BEFORE THE OHIO POWER SITING BOARD

In the Matter of the Application of Icebreaker)	
Windpower Inc., for a Certificate to Construct)	
a Wind-Powered Electric Generation Facility)	Case No. 16-1871-EL-BGN
in Cuyahoga County, Ohio.)

ICEBREAKER WINDPOWER INC.'S RESPONSES TO THE THIRD SET OF INTERROGATORIES FROM THE STAFF OF THE OHIO POWER SITING BOARD

2016 Lake Bottom Current Velocity and Direction at ICE4
Note: Spokes represent the frequency of currents moving towards a particular direction

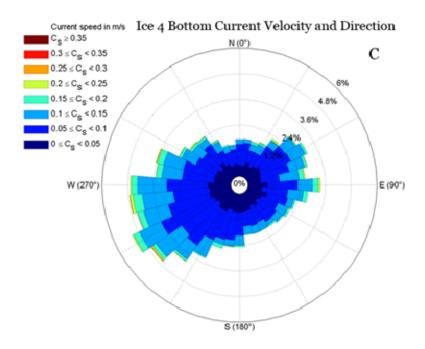
9) Page 77 of the application indicates that the general flow of Lake Erie in the project vicinity is east to west. Please confirm or correct.

Response: Yes. The general flow of Lake Erie in the Project vicinity is east to west. See current rose below.

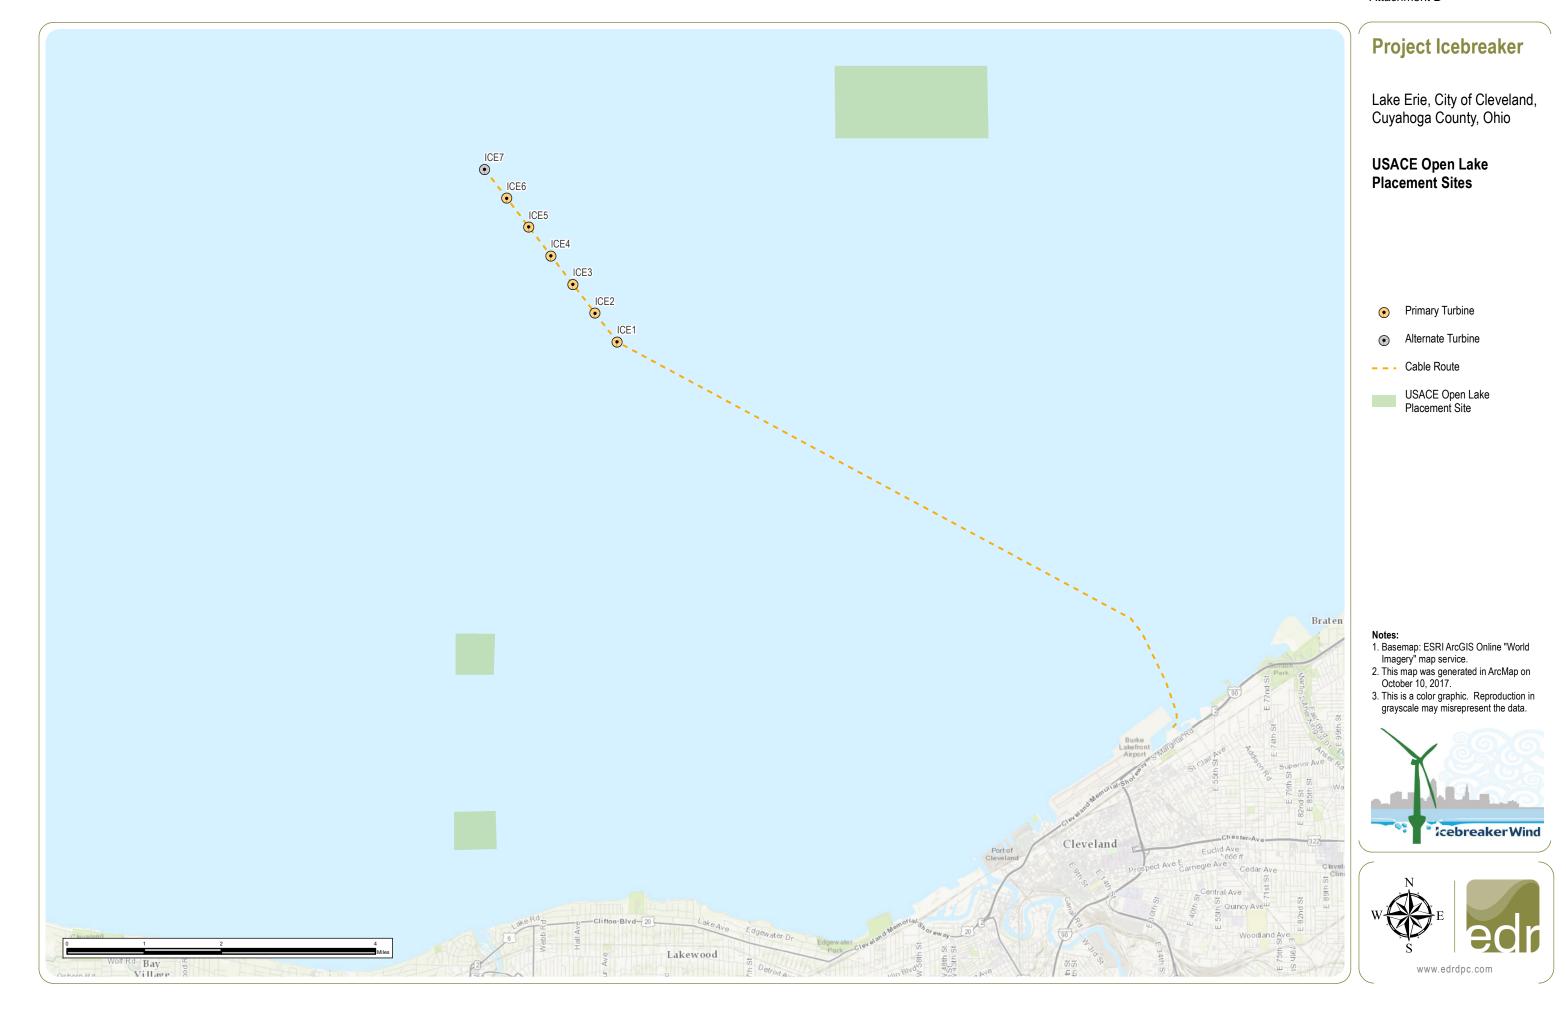
5) Please confirm that the electric line construction corridor does not contain any known areas of toxic material or areas of open lake placement for dredging material (see Cleveland Water letter).

Response: The electric line corridor does not pass over or near any known areas of open lake placement for dredging materials or other known areas of toxic material. The closest distance to the any open lake placement site is 2 miles. See **Attachment B**, which shows the open lake placement site 2 miles away.
